Grays Harbor Energy Center  
Application for Site Certification Amendment  
Data Request 1 – GHE Responses

### **Data Request 1 – GHE Responses**

Figure 1

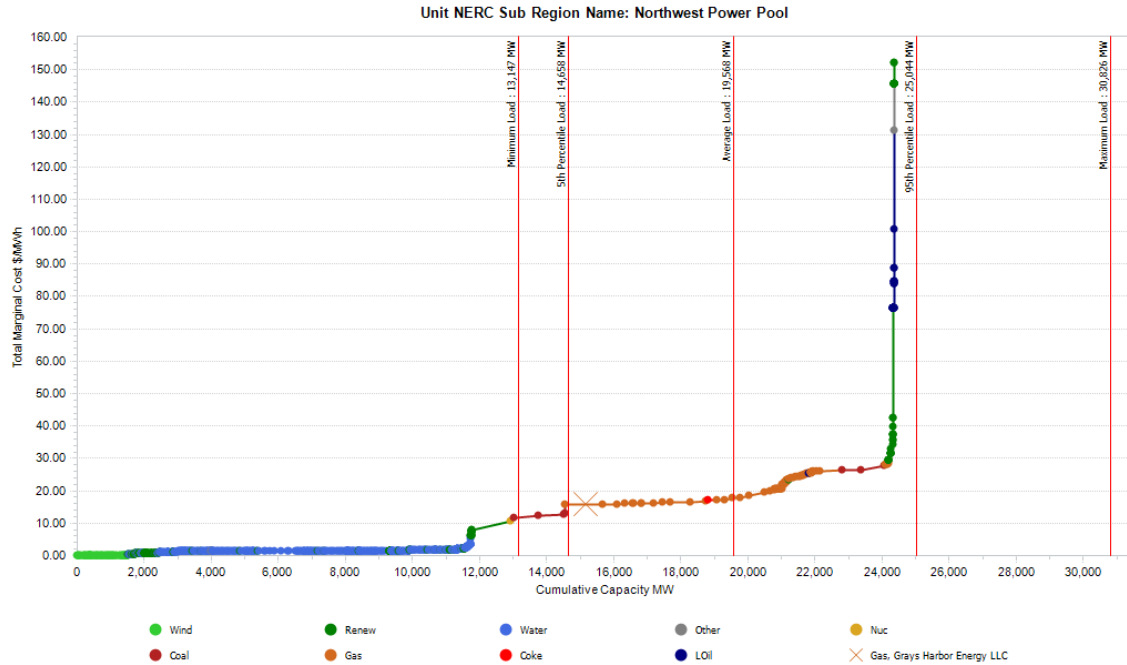
The request letter states, “Consequently, the increase in CO<sub>2</sub> emissions from the Grays Harbor Energy Center is offset by emissions avoided at less efficient facilities that would otherwise operate to meet power and demand needs.” Please provide supporting data for this statement, including, but not limited to, any documentation that supports the stipulation that GHEC is operated in priority over less efficient gas-based generation facilities.

When looking specifically at the Northwest Power Pool, as shown in the supply curve below sourced from ABB’s Velocity Suite software, Grays Harbor Energy Center is one of the most efficient gas-powered units. Any additional capacity added to GHE would displace capacity that would otherwise be produced by less efficient units shown to the right of the “X” mark on the below graph when it is needed.

Figure 4

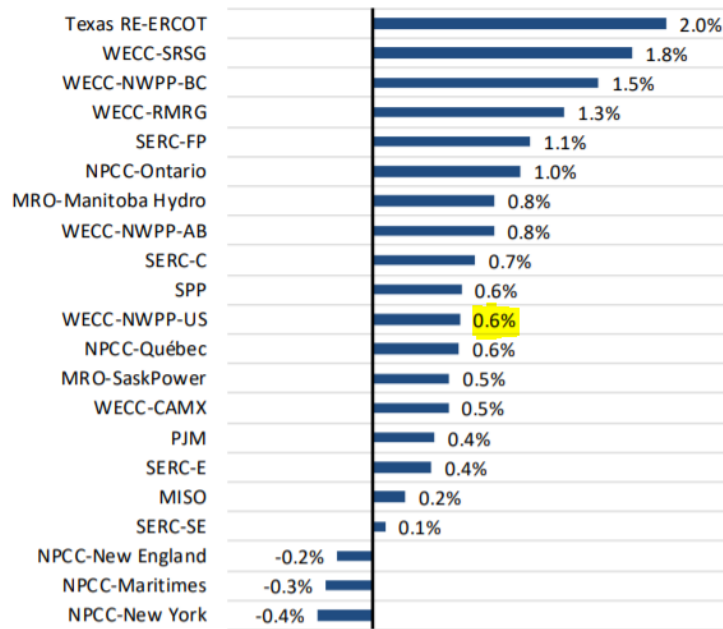
Please provide data to support projections for expected increase in gas-based generation. Please include in this data, how the retirement of coal-based generation aligns with these projections.

The NWPP is a sub-region of WECC. Expected coal retirement capacity between 2019 and 2030 in WECC is around 18,000 MW.<sup>2</sup> Additionally, according to NERC’s 2019 reliability assessment report, peak power demand in the NWPP is expected to grow annually by 0.6%.<sup>3</sup>

With fewer coal generating units operating to meet growing power demand, the region will need increased production from existing natural gas generators. In summary, gas-based generation will be needed to help “fill the gap” between supply and demand left from the retired coal capacity.

Figure 5

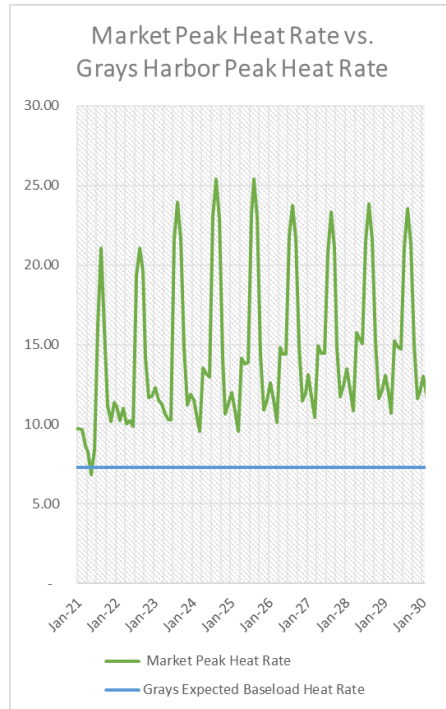
Please provide rational, including relevant data or projections, for extending the construction window to 2028. Please include discussion on why construction has not been feasible to this point.

The below graph sourced from S&P Global Platts shows a comparison of GHE’s peak heat rate vs. the market implied peak heat rate forecasted for the next 10 years.<sup>4</sup> The market implied heat rate is calculated by dividing the forecasted average on peak and off peak power prices by the gas prices. The green line represents the generator with the highest marginal cost which would ultimately set the market clearing price and the blue line represents the average heat rate at GHE. In other words, if the GHE heat rate (the blue line) is below the market peak heat rate (the green line), the GHE will be dispatched.

The graph illustrates that the implied market heat rate for a gas power plant in the region is expected to exceed GHE’s heat rate in every month but one for the next ten years. In other words, GHE is projected to procure gas and sell power at a lower cost than other units in the region for almost the entire period. Because market dispatch is based on efficiency, GHE is expected to operate in priority to other gas generating units 99% of the time over the next ten years.

As evidenced by Figure 5 above, the implied market heat rate in the NWPP is expected to increase throughout the decade, indicating a growing need for gas-fired generation. GHE's request to extend the construction window of Units 3&4 to 2028 is based on a projected need for gas-powered generation in the region in the latter half of the decade. The last projected coal plant retirement in the NWPP is expected to occur in 2027 when Colstrip retires Units 3&4 and capacity in the region decreases by 1,480 MW (see Figure 3). We also understand that according to NERC, power demand in the NWPP is expected to increase 0.6% annually.<sup>5</sup> It takes approximately two years to construct a power plant, so we would have to start construction by 2028 in order to be operational in 2030. In summary, extending the construction deadline for Units 3&4 through 2028 allows GHE to observe changing market conditions as coal plants retire and help fill a potentially large gap between dispatchable and reliable power supply and demand.
